Subject: AP1000 Response to Request for Additional Information (SRP 6)

AP1000 TECHNICAL REPORT REVIEW

RAI Response Number: RAI-SRP6.4-SPCV-15
Revision: 1

6.4 Habitability Systems

Figure 6.4-2 (Sheet 2 of 2)
 Main Control Room Habitability System
 Piping and Instrumentation Diagram

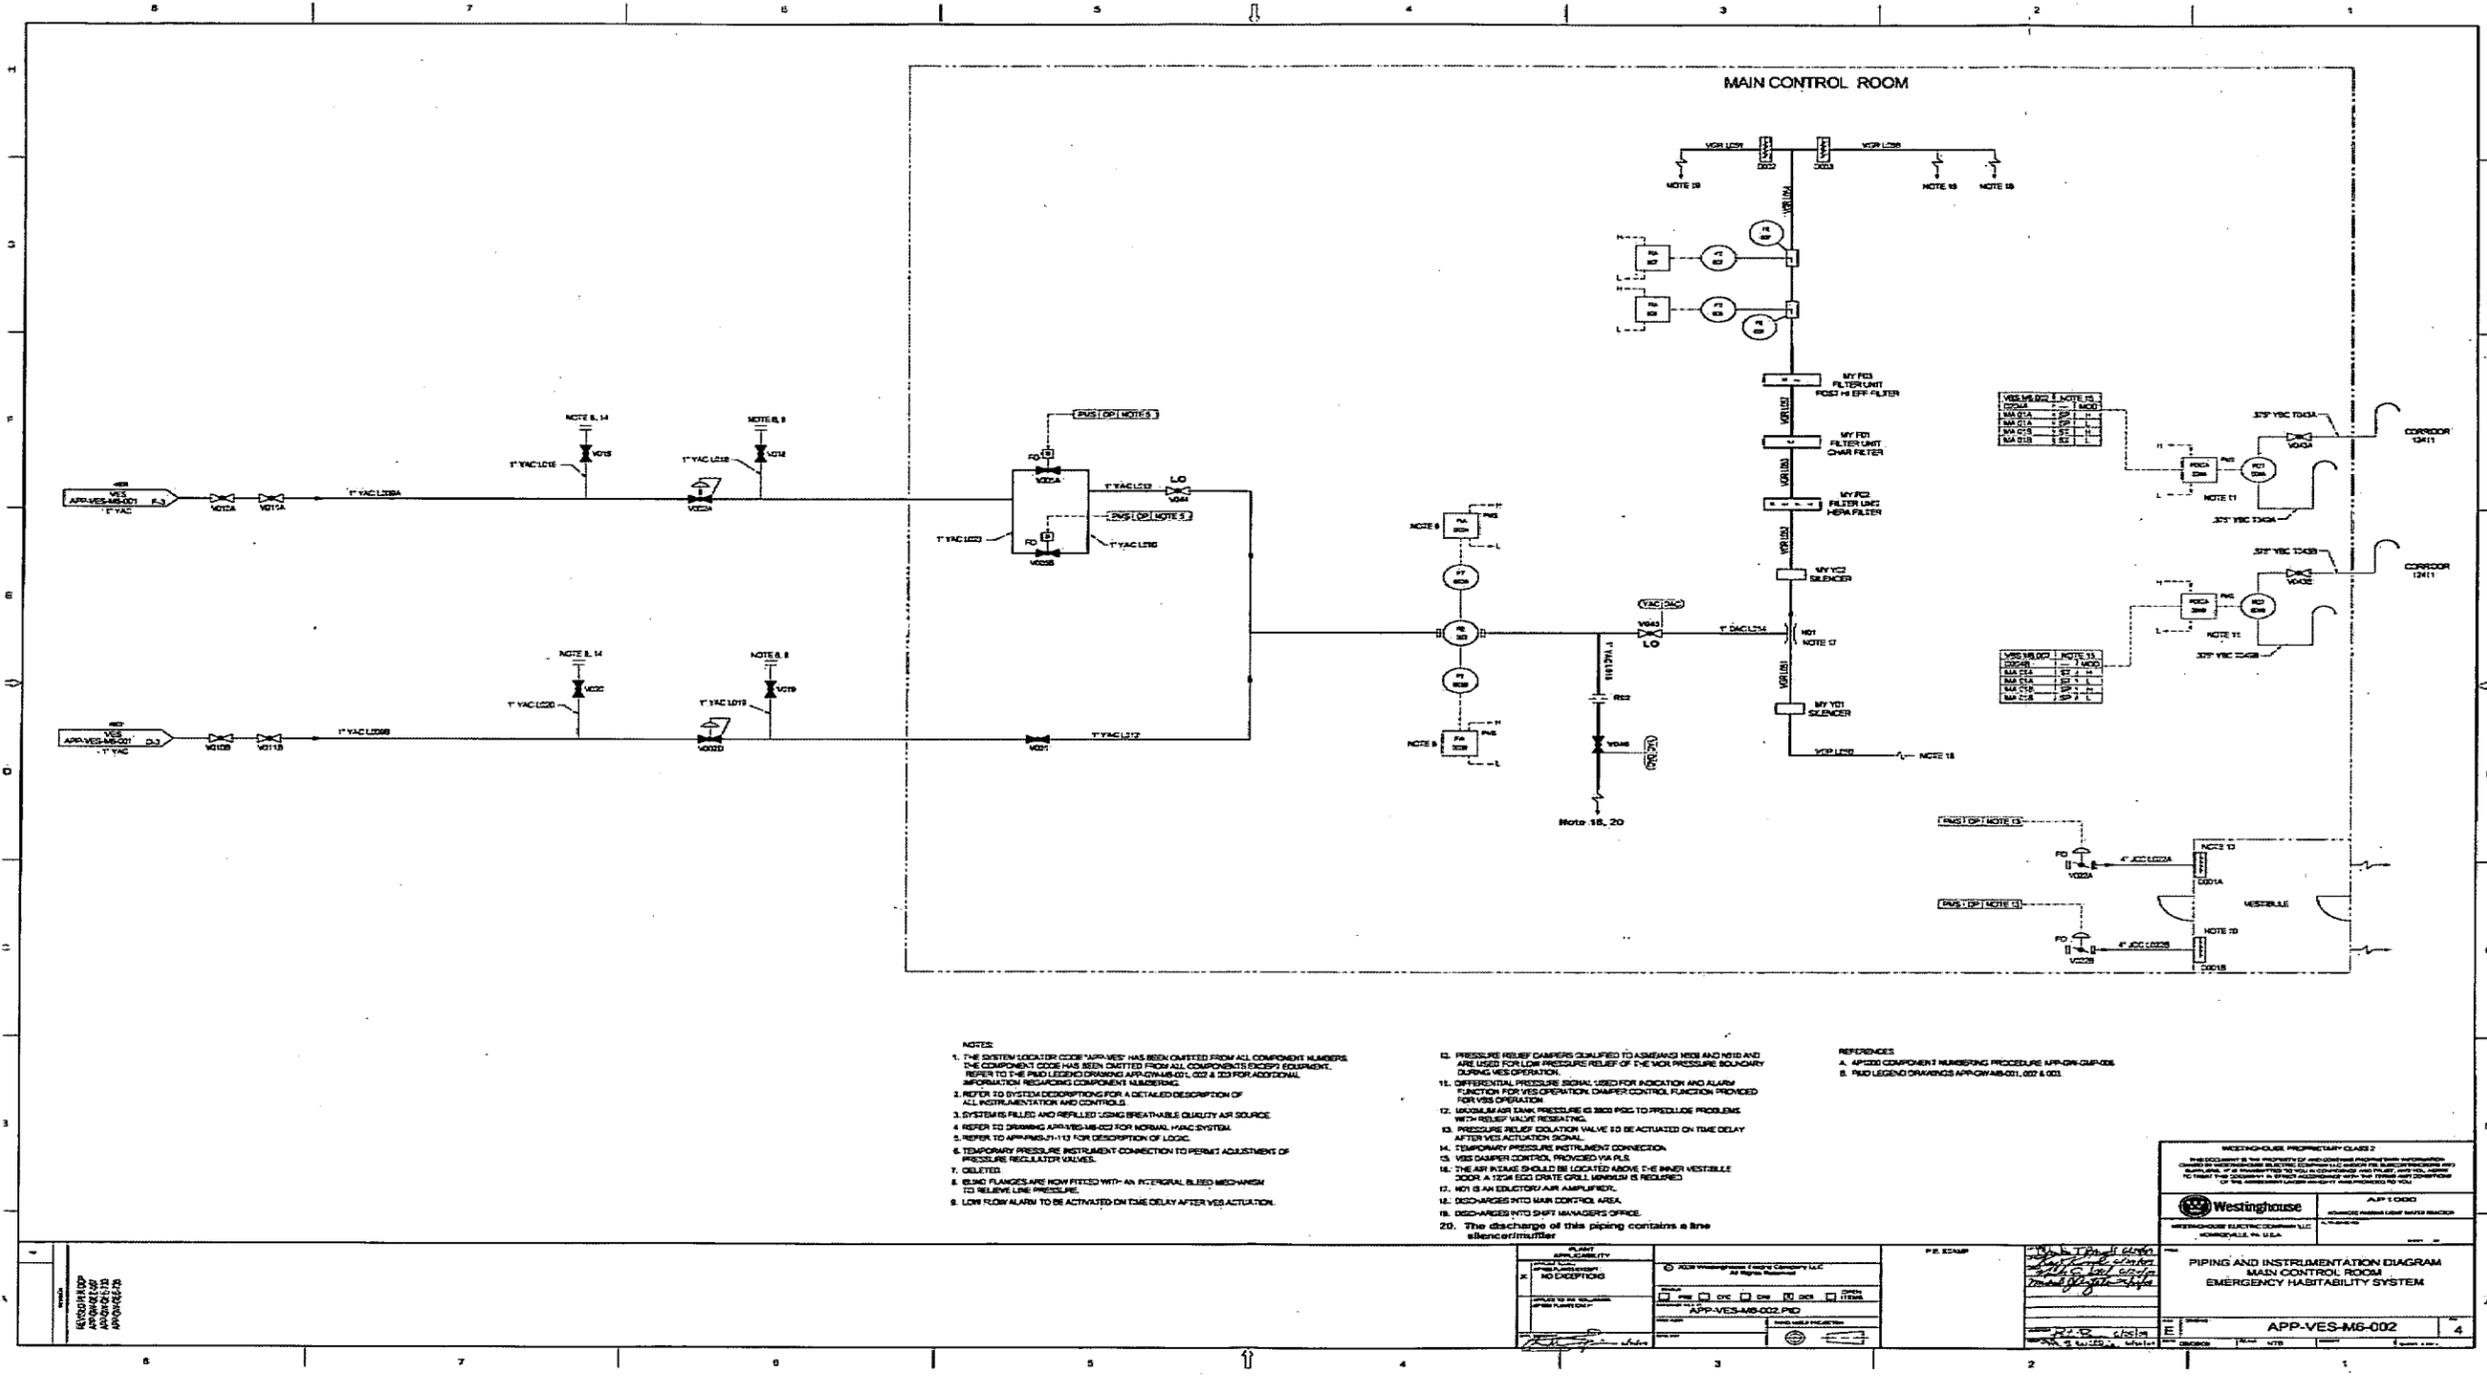
RAI-SRP6.4-SPCV-13 R0	<p>Section 6.4.2.2 Section 6.4.4 Section 6.4.8</p>	
RAI-SRP6.4-SPCV-13 R1	<p>Tier 1 Table 2.2.5-1 (Update table) Figure 2.2.5-1 (replace figure)</p> <p>Tier 2 Table 3.2-3 (Update table) Table 3.9-12 (Update table) Table 3.9-16 (Update table) Table 3.11-1 (Update table) Section 6.4.2.2 Section 6.4.2.3 Section 6.4.4 Section 6.4.8 Figure 6.4-2 (Sheet 2 of 2) (replace</p>
